**ADDRESS: 425 S 42ND ST**

Proposal: Construct accessible ramp, entrance vestibule, and gate with signage

Review Requested: Final Approval

Owner: Cornerstone Christian Academy

ROOF DEMOLITION PLAN  
1/16" = 1'-0"

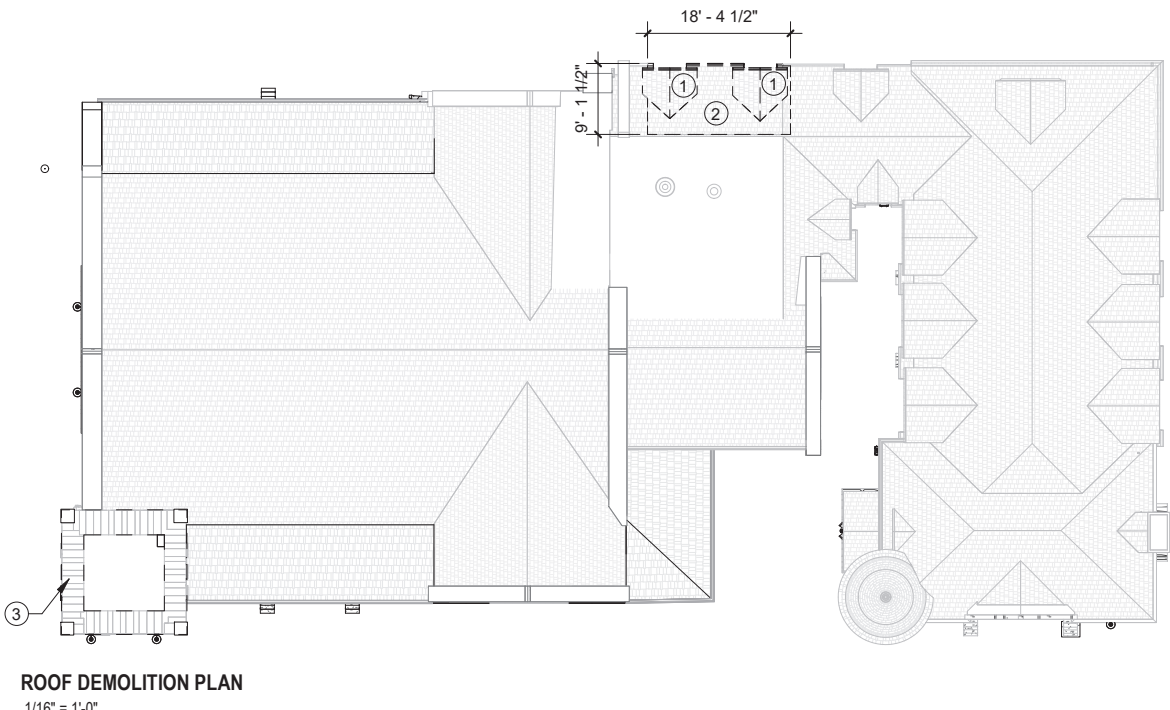
- The proposed demolition permanently removes the south elevation entrance steps and north elevation dormers and roofline. The applicant should document both areas of the project in detail to allow for possible future restoration. If the documentation is completed and provided to the Historical Commission, this application will satisfy Standard 10.

**ENLARGED RAMP PLAN**

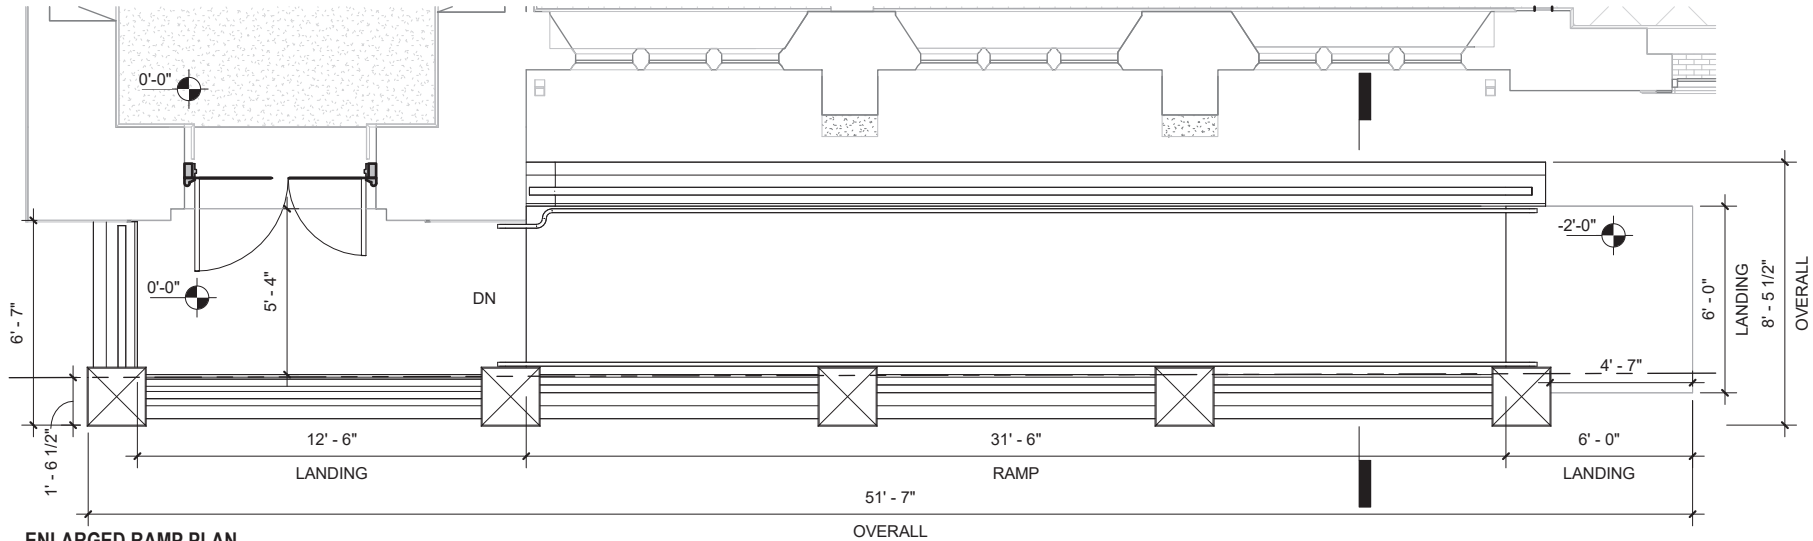
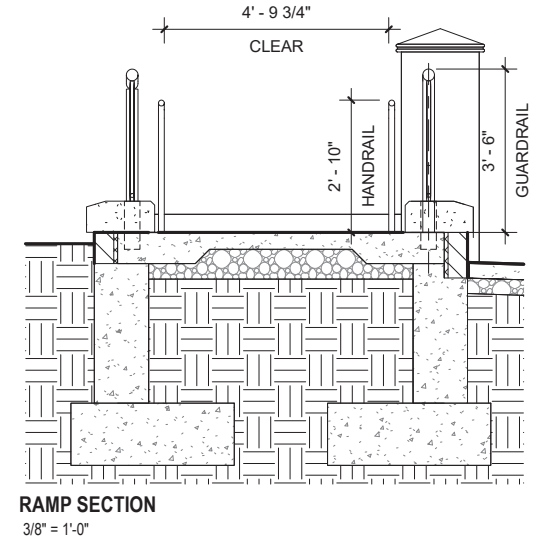
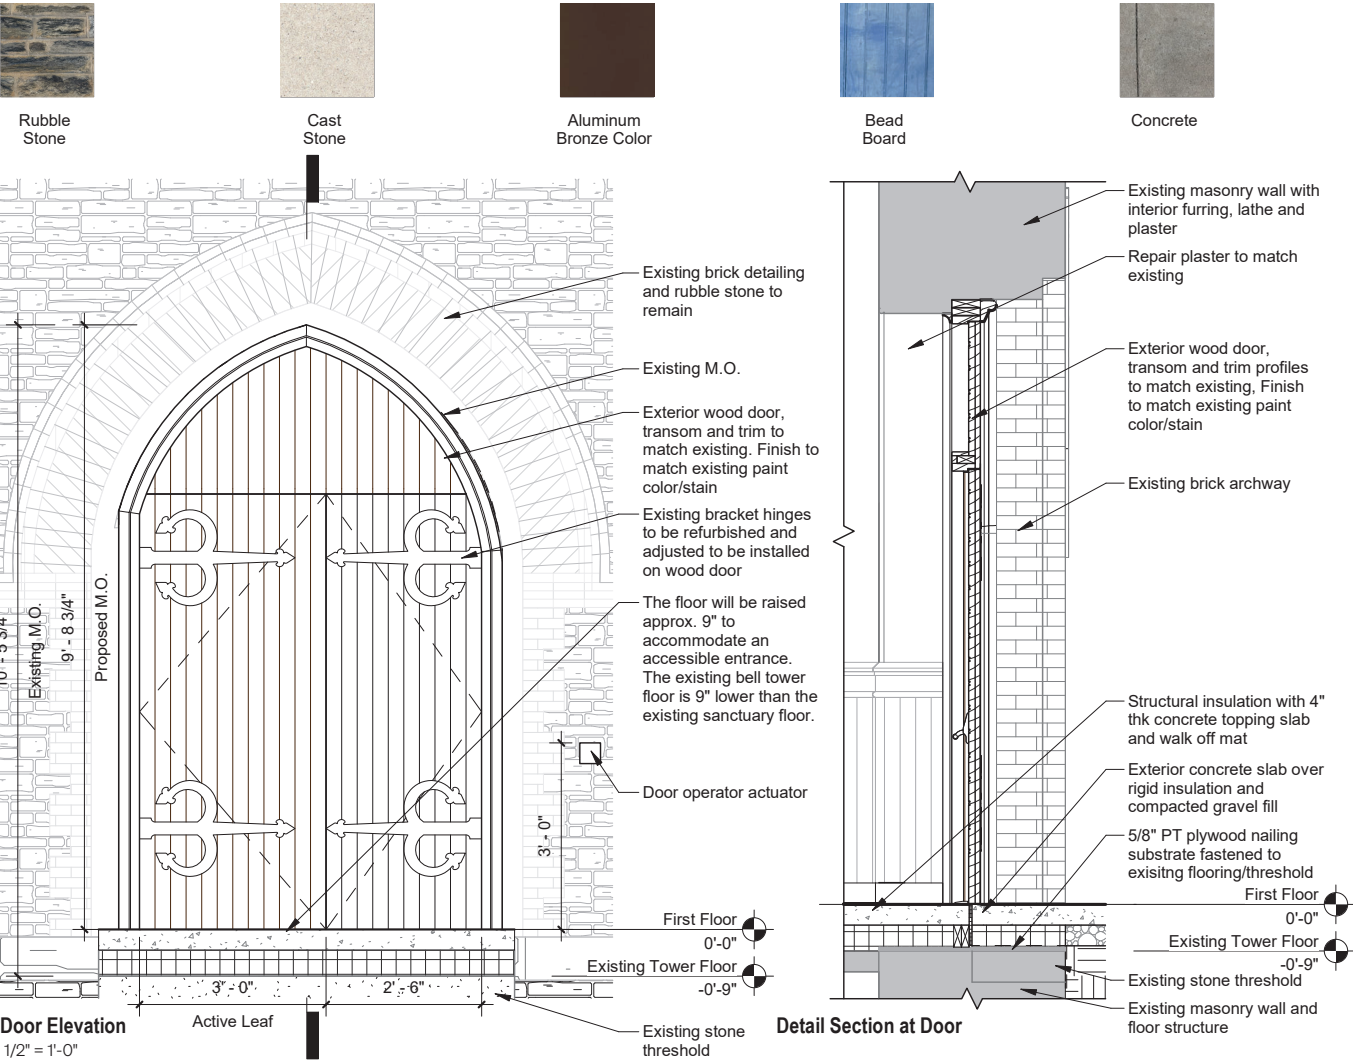
- The construction of an accessibility ramp on the south elevation could meet Standard 9 with modifications to the proposed design. While the general design and materials of the ramp are compatible with the historic building, specific details increase the visual mass and scale of the new ramp. The staff recommends eliminating the cast stone balustrade at the top of the ramp and replacing it with a metal picket railing. Reducing the width of the ramp's columns and modifying the color or material would reduce their prominence in the design and increase compatibility with the historic building.
